CITY OF GLENDALE, CA

DESIGN REVIEW STAFF REPORT – SINGLE FAMILY

July 30, 2025 <i>Decision Date</i>	3325 Mills Avenue, Glendale, CA 91214 <i>Address</i>
Administrative Design Review (ADR) <i>Review Type</i>	5607-015-021 <i>APN</i>
PADR 004911-2025 <i>Case Number</i>	Narek Zakaryan <i>Applicant</i>
Paulina Safarian, Associate Planner <i>Case Planner</i>	Cynthia Dely <i>Owner</i>

A PROP. SITE PLAN

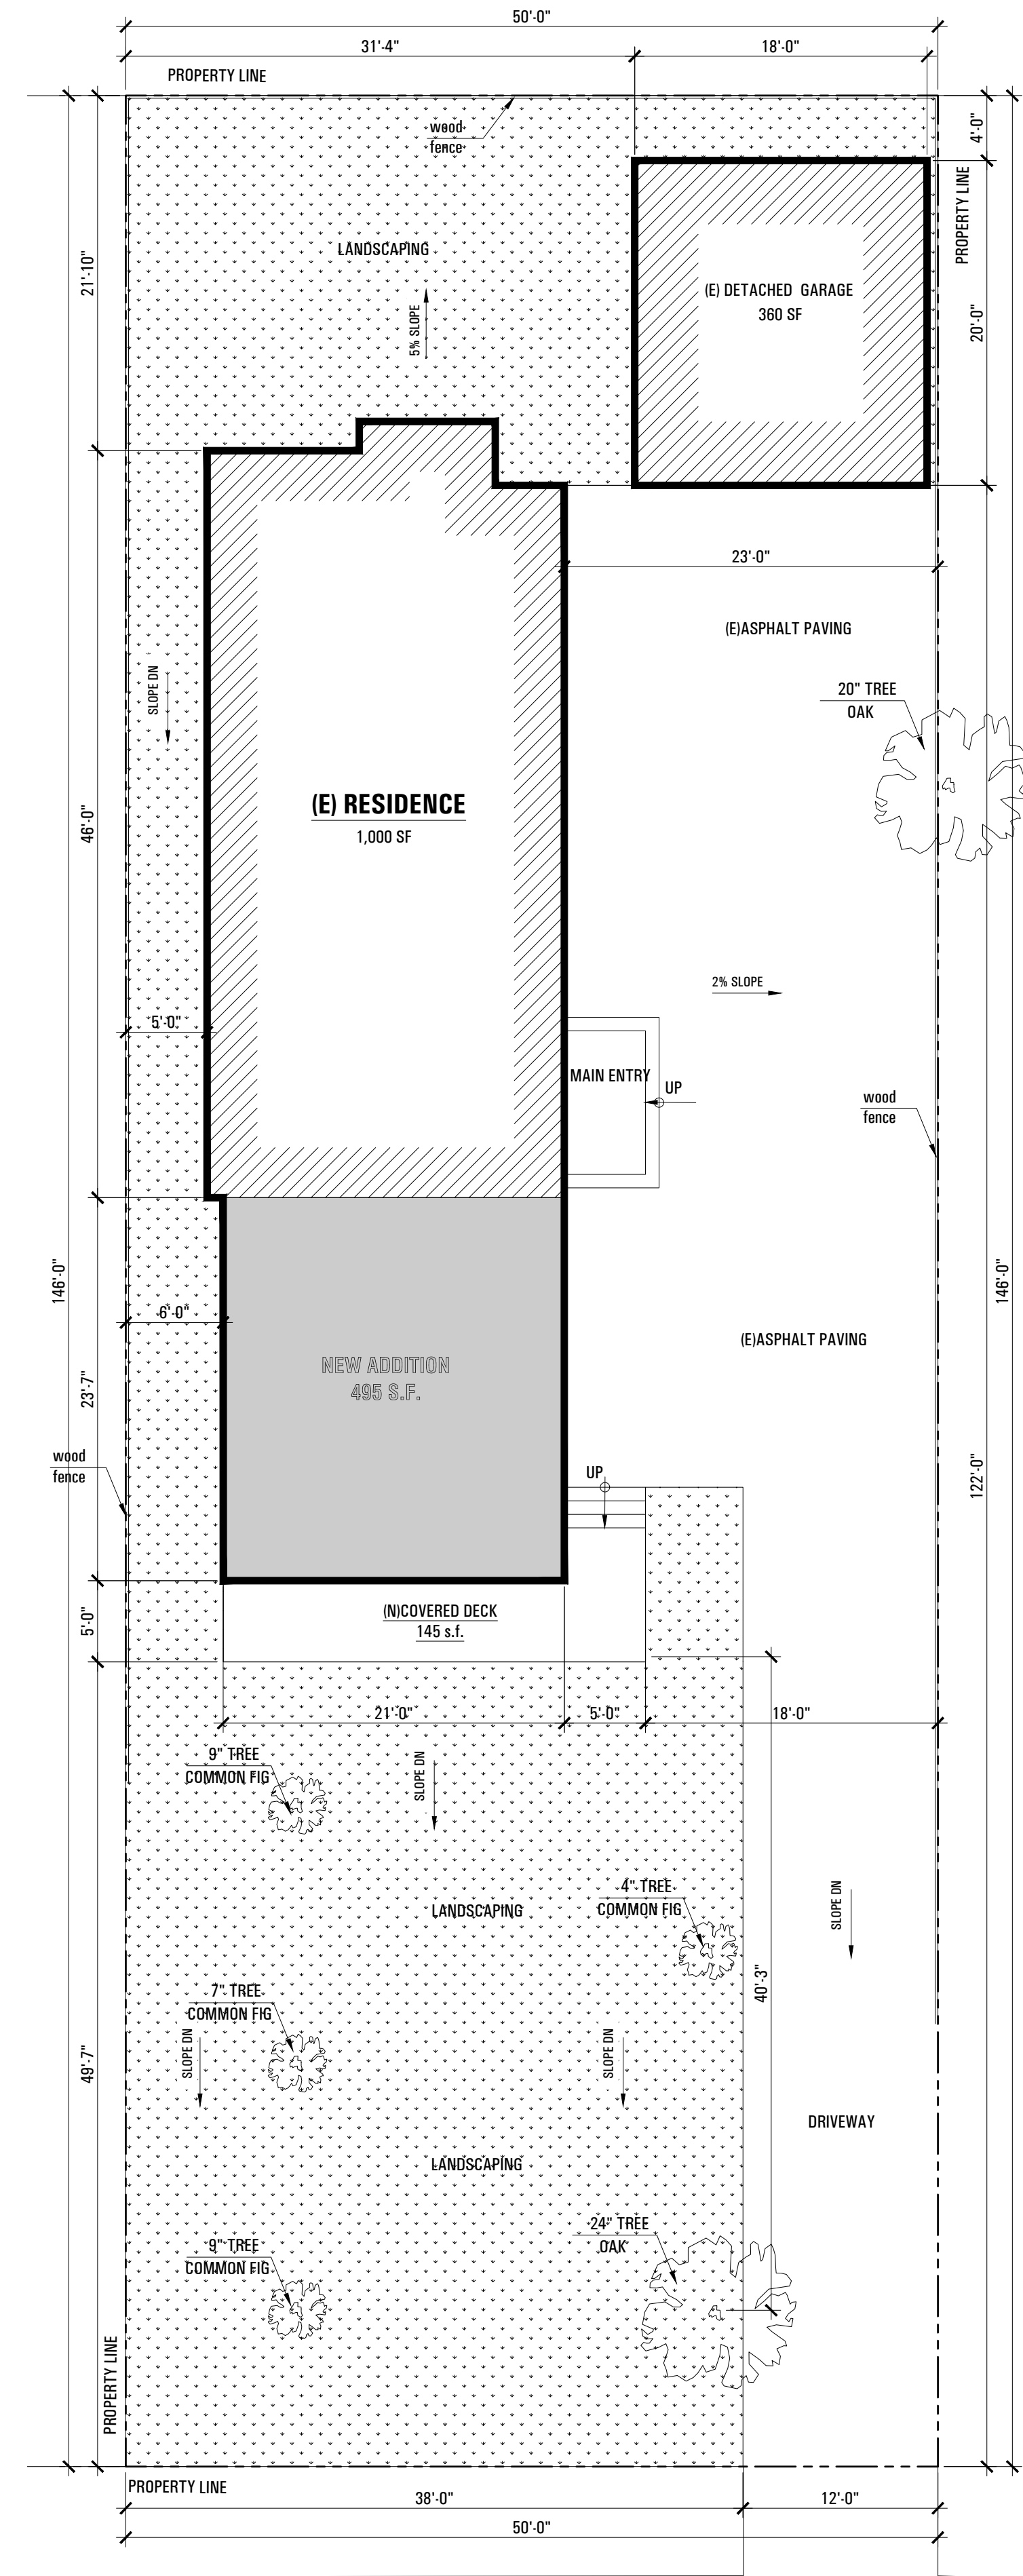
Currently, there is one privately owned *Quercus agrifolia* (coast live oak) noted on the site plan. Indigenous Protected Trees on abutting properties within 20 feet of a boundary line have not been represented on plans. There are no City trees in the public right-of-way, and a condition for new City parkway trees will not be required by the City’s Urban Forestry Division at this time. The City’s Urban Forestry Department has reviewed the application and did not cite any major concerns with the proposal.

- The existing landscaped areas will remain in its current form and appropriately maintained. A staff recommended condition of approval requires the applicant to comply with the Urban Forestry Department Comments, dated June 16, 2025, which required the applicant to add the note, “Protected oak, sycamore, bay trees or City Street trees on the property and within 20’ of the property are inaccessible to the proposed construction activity and will experience NO impact. No protective fencing is required” to the plans. An additional comment states to “Accurately represent Indigenous Protected Trees on site and within 20’ of property, to scale and accurate location. Diameter at breast height (DBH) and proper name shall be included on plans”.

Trash storage location is not identified on plans. A condition is included to identify an appropriate trash area on the plans (e.g., at the northern backyard behind home, not encroaching into the setback area and not visible from public street view). Additionally, a condition is included requiring the applicant to clearly depict downspouts on the building elevations for staff review and approval.

1. The applicant shall comply with all of the recommendations identified in the Urban Forestry Department Comments dated June 16, 2025.
2. That trash area location be identified and appropriately located on the site plan, and show downspouts on the elevation drawings for staff review and approval.
